Title:Permit 19-614 & W19-38: 3537 Zenith Avenue South, Minneapolis: Bakken MuseumPrepared by:Name: Heidi Quinn
Phone: 952.641.4504
hquinn@minnehahacreek.org

Recommendation: Approval of MCWD permit application on the following conditions:

Revised Figure 2 - Existing Conditions (2016 MnGEO Photo)

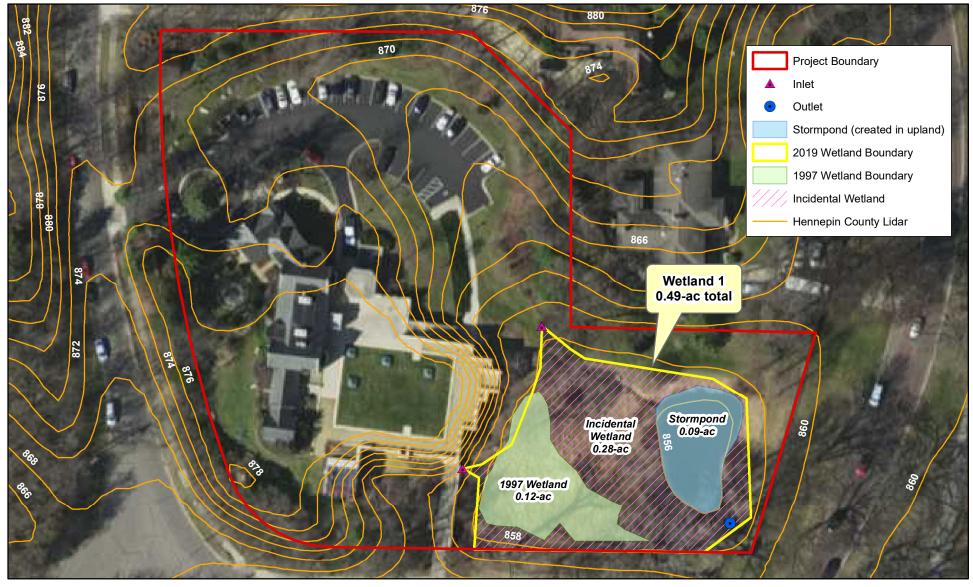
The submitted Revised Figure 2 adequately represents the wetland boundary regulated under WCA and the extents of the incidental wetland area not within the scope of WCA.

Figure 3 - Wetland Impact

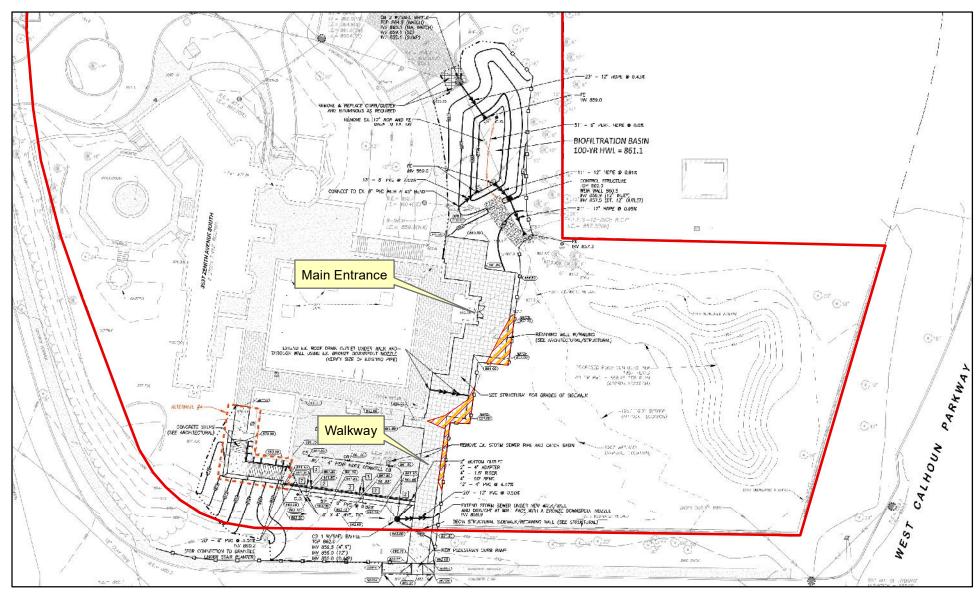
Construction of the new site entrance and corresponding walkway will result in 370 sf of fill impact to Wetland 1 (**Figure 3**). The area proposed for impact is Type 1 (PEMA) wet meadow wetland, a portion of which is incidental.

This plan does not allow for buffer along the west site of Wetland 1. Because it is not prudent to fill wetland to created buffer, the Applicant will also be applying for a MWCD buffer exemption (separate submittal).
